**1<sup>st</sup> Further Information**

**Proposed Temporary Shop and Service with Ancillary Facilities for a Period of 5 Years  
in “Village Type Development” Zone, Lots 1289 (Part) and 1293 (Part)  
in D.D. 113, Cheung Po, Kam Tin, Yuen Long, New Territories**

**(S.16 Planning Application No. A/YL-KTS/1005)**

**Responses-to-Comments**

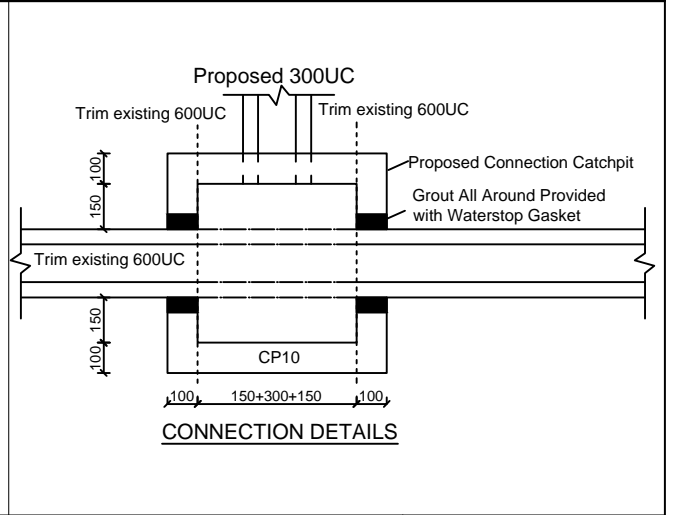
Departmental Comments		Applicant’s Responses
<b>1. Comments of the Chief Engineer/Mainland North, Drainage Services Department</b>		
(a)	Rainfall intensity of 250mm/hr is a adopted for the calculation, please substantiate.	A revised drainage proposal is provided ( <b>Annex I</b> ). Calculation of i is presented.

(c)	Where walls or hoarding are erected or laid along the site boundary, adequate opening should be provided to intercept the existing overland flow passing through the site.	Noted. Typical details of wall opening have been provided.

SITE AREA = 512 SQ.M(C=0.95), Outside Catchment Area 1 = 1145 SQ.M (C=0.95),  
 Outside Catchment Area 2 = 1165 SQ.M (C=0.25)  
 $Q = 0.278C_iA$   
 $= 0.278 \times 0.95 \times 195 \times 512 / 1000000 + 0.278 \times 0.95 \times 195 \times 1145 / 1000000 + 0.278 \times 0.25 \times 195 \times 1165 / 1000000$   
 $= 0.1011 \text{ M}^3/\text{S}$   
 $= 6067 \text{ lit}/\text{min}$   
PROVIDE 300UC (1:100) IS OK (FIG. 8.7)

- Catchpits (CP4) with desilting facility shall follow CEDD standard drawing No. C2406I.
- Catchpit and UC follows Typical Details of Geotechnical Manual for Slope Fig.8.10 and Fig.8.11 respectively.
- Adjacent area which is developed or occupied, which has their stormwater collection system.
- The runoff generated from the site is originally collected by the existing open channel, and there is no change of paving condition, i.e. no extra runoff to the existing 600UC.

Catchment Area Plan

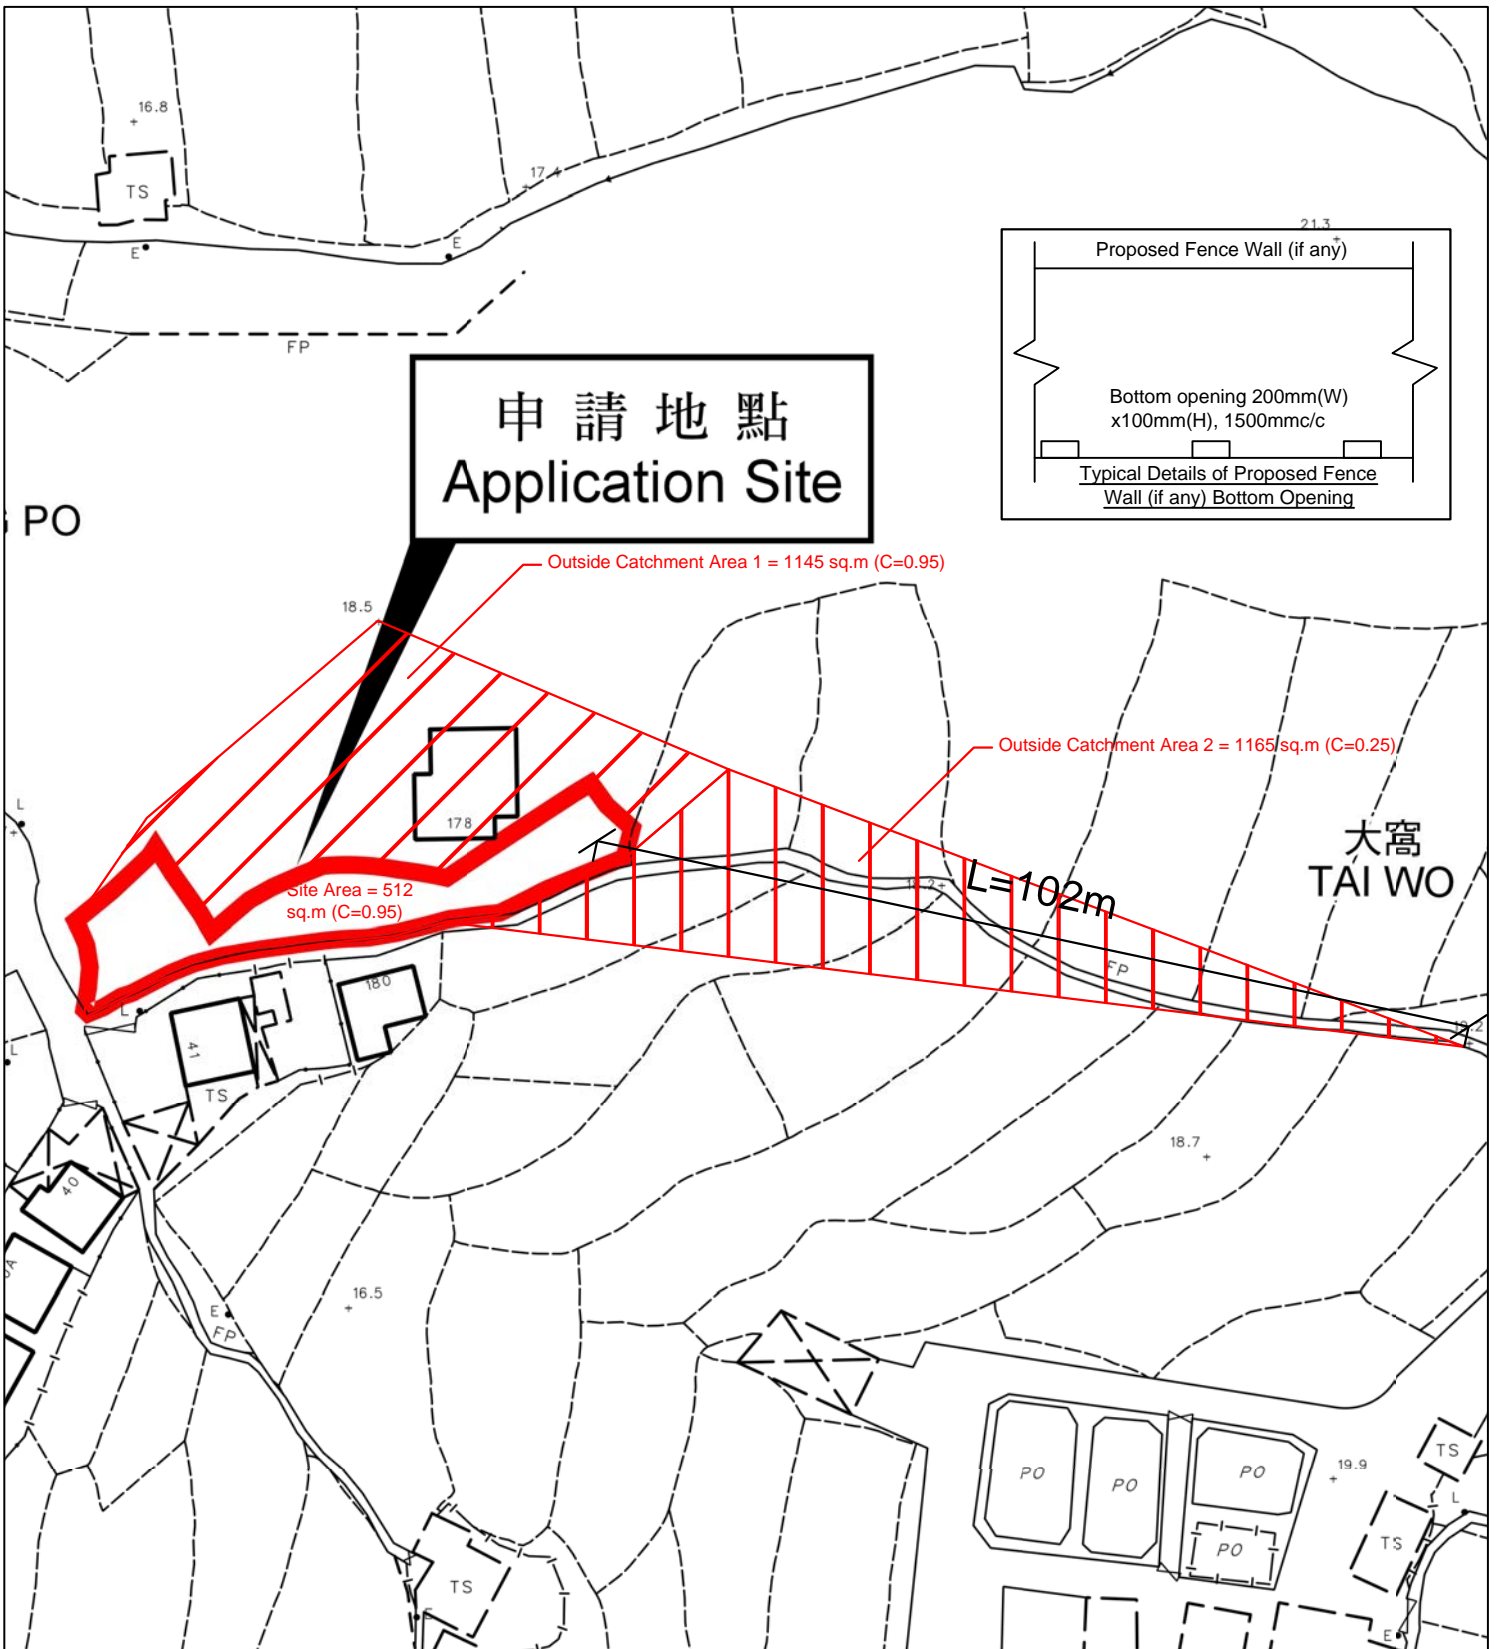
(b)	The ground to the east of the application site is generally high. Since the overland flow from the adjacent lands shall be probably intercepted, external catchment shall be considered in the calculation. Please revise the levels showed in Section B-B accordingly.	Extra catchment area from east of the application site (the Site) has been considered and Section B-B is revised accordingly.

Calculation of i,

$$\begin{aligned} A &= 2822 && \text{m}^2 \\ &= 0.002822 && \text{km}^2 \end{aligned}$$

$$\begin{aligned} t &= 0.14465 L / H^{0.2} A^{0.1} && (L=102\text{m}, H=35) \\ &= 0.14465 * 102 / 35^{0.2} * 2822^{0.1} \\ &= 0.80 && \text{min} \end{aligned}$$

$$\begin{aligned} i &= a / (t+b)^c && (\text{Values of a, b and c are from 10years return period,} \\ &= 1157.7 / (1.85 + 19.04)^{0.597} && \text{Table 3d of SDM2018)} \\ &= 194.35 && \text{mm/hr} \end{aligned}$$

take  $i=195$  mm/hr
